# DELEGATED DECISIONS BY CABINET MEMBER FOR TRANSPORT MANAGEMENT

# ROAD SAFETY & PEDESTRIAN IMPROVEMENT SCHEME – CHILTON, LOWER ROAD

Report by Director of Environment and Highways

Annexes Annex 1: Consultation plan

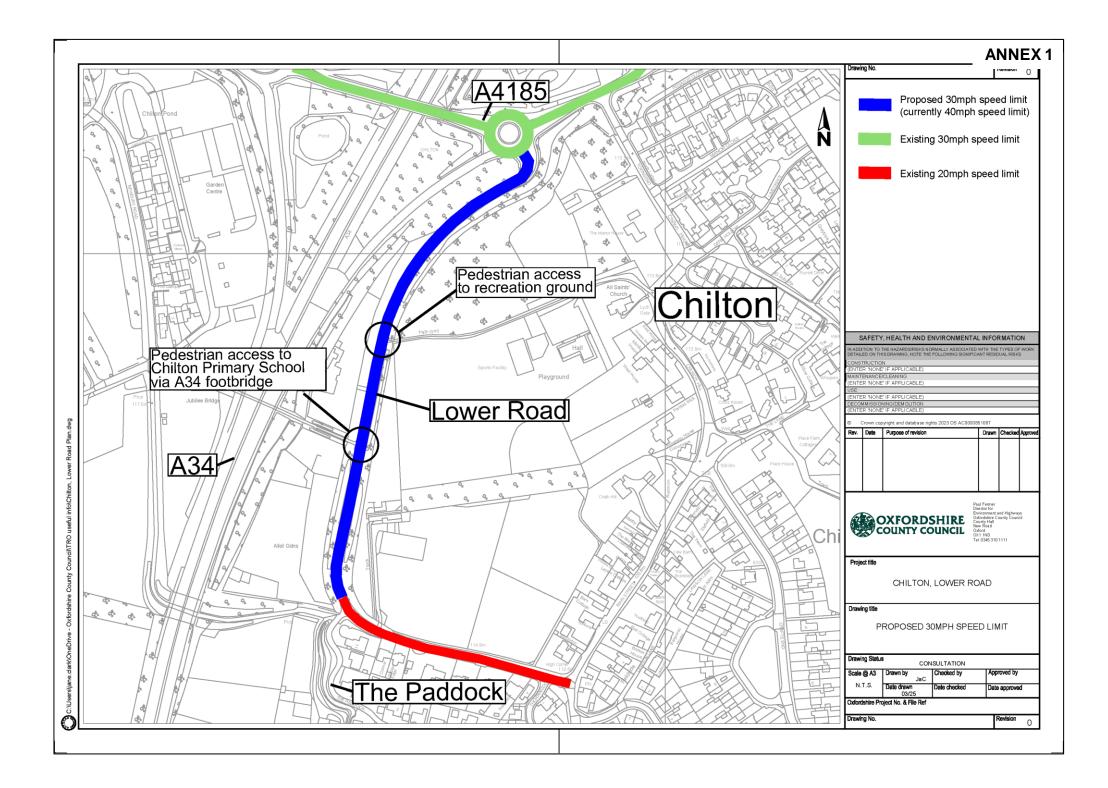
RESPONDENT	COMMENTS
(e1) Traffic Management Officer, (Thames Valley Police)	No objection – Thames Valley Police welcome the opportunity to engage on plans for road safety improvement. There are other reasons 30mph limits may be desirable for communities, such as environmental concerns, and creating a shared space environment to encourage greater diversity of road users.  Compliance with some speed limits is a challenging issue as there is a difference between the achievable results of the various available schemes. For example a sign-only scheme will only have a limited effect on the mean speeds, as opposed to other schemes that influence the road environment, which is recognised as being key to achieving compliance. If a speed limit is set too low and is ignored then this could result in the vulnerable road user being less safe. It can also cause a dis-proportionate number of drivers to criminalise themselves and could bring the system of speed limits into disrepute.  Thames Valley Police have no policy to enforce based on arbitrary speed limits alone but will enforce based on threat

<ul> <li>existing traffic speeds (No speed data has been provided to support this proposal)</li> <li>road environment</li> <li>Speed limits should be considered as part of a package of measures to manage vehicle speeds and improve road safety. Changes to the highway (for example through narrowing, providing vertical traffic calming or re-aligning the road) may be required to encourage lower speeds in addition to any change in speed limit. Though these may be more expensive, they are more likely to be successful in the long term in achieving lower speeds without the need for increased Police enforcement to penalise a substantial number of motorists. Self-Enforcement using Community Speed Watch would be another option to consider/explore.</li> </ul>
(e2) Managing Director, (Thames Travel)	Support
(o1) Local resident, (Chilton, Lowr Road)	Object – I do not support the proposal to lower the speed limit on this particular stretch of road. Having lived in very close proximity to it for over 10 years, I am not aware of a single incident involving injury or collision. The road has a pavement for pedestrians, meaning there is no shared road space, and there are no residential driveways along this section requiring vehicles to enter or exit. It is primarily used by local domestic vehicles, not commercial traffic. In fact, this stretch is technically already prohibited to motor vehicles under the existing signage — a restriction that is not currently enforced.

Given this context, introducing a lower speed limit appears unnecessary and unlikely to be effectively enforced, particularly when the existing prohibition is not being upheld.
	I am concerned that this proposal represents a misallocation of time and resources. Nearby roads such as Hagbourne Hill experience significantly higher volumes of traffic — including school transport, HGVs, agricultural vehicles, and cyclists — and have a history of serious accidents, including fatalities. These roads pose a far greater risk to public safety and are more deserving of attention. I witness near misses on this stretch of road an almost daily basis.
	In summary, I urge you to reconsider this proposal and instead focus efforts where there is clear evidence of danger and a real opportunity to improve safety outcomes.

(o2) Local resident, (Eynsham, Back Lane)	Object – It will will not improve safety and will increase pollution and congestion as proved everywhere you have already done it
(o3) Local group/organisation, (Coalition for Healthy Streets & Active Travel)	<b>Support</b> – We support this proposal to improve the safety of pedestrian and cycling users of this road and access to the pedestrian overbridge and the pedestrian/cycling subway crossings of the A34. I have personal experience of using the bridge and underpass on this road on a fairly frequent basis, as do others I know who walk and cycle in this area. The 40mph speed limit is out of context for the village setting and the high traffic speeds are an unnecessary danger and will put some people off from using the road and crossings to access the garden centre and the Ridgeway.
(o4) Local resident, (Chilton, Fieldside)	Support – over the distance of this section of road the likely increase in journey time is 10s max (diff between 30 and 40 mph) and likely to be less in reality. Given that drivers exceed the 20 mph speed limit coming into the village, reducing the Lower Road limit will increase safety through more likely compliance with the following 20 mph section. The change also improves safety for road users and pedestrians crossing the road to use the foot bridge.

- 13. The objection states that there is an off-carriageway pavement for pedestrians as part of this scheme there are proposals to install drop kerbs at the entrance to Jubilee Bridge, and also on the opposite side of Lower Road to help improve accessibility for vulnerable users which should increase the use of the facility, especially by children accessing Chilton School and the playground at the Village Hall.

- 14. The lower speed limit is proposed to help standardise the current speed restrictions in the area, as there are currently lower limits either side of these proposals.

- 15. Speed surveys were carried out week commencing 05th May 2024, the results showed that mean speeds were below 33mph in either direction resulting in the location complying with Oxfordshire County Council policy for a sign only reduction in the posted speed limit to 30mph.

- 16. Officers feel that the proposals will help improve road safety by reducing vehicle speeds, and thus allowing safer movements for the more vulnerable road users (i.e. pedestrians & pedal cyclists).
